Application No.	Applicant(s)			
	10/566,583	KAMEDA, FUTOSHI			
Office Action Summary	Examiner	Art Unit			
	LINDSAY M. LOW	3721			
The MAILING DATE of this communication app	pears on the cover sheet with the c	orrespondence address			
Period for Reply					
A SHORTENED STATUTORY PERIOD FOR REPL' WHICHEVER IS LONGER, FROM THE MAILING D. - Extensions of time may be available under the provisions of 37 CFR 1.1 after SIX (6) MONTHS from the mailing date of this communication. - If NO period for reply is specified above, the maximum statutory period of Failure to reply within the set or extended period for reply will, by statute Any reply received by the Office later than three months after the mailing earned patent term adjustment. See 37 CFR 1.704(b).	ATE OF THIS COMMUNICATION 36(a). In no event, however, may a reply be tin will apply and will expire SIX (6) MONTHS from , cause the application to become ABANDONE	N. nely filed the mailing date of this communication. D (35 U.S.C. § 133).

DETAILED ACTION

1. This action is in response to applicant's RCE received on April 3rd, 2008.

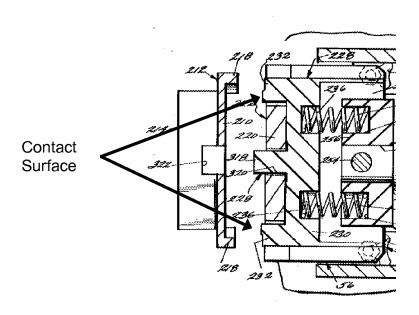
Regarding the amendment to claim 1, the contact surface (designated below) does not contact the guide surface in the absence of staples. Note that each projecting portion 232 has two surfaces facing the guide surface (best seen in Fig 15 below), and the designated contact surface is not contacting the guide surface. In addition, note that when the pusher 228 is in the position shown in Fig. 15, it is not contacting the guide surface at all and therefore the contact surface is also not contacting the guide surface.
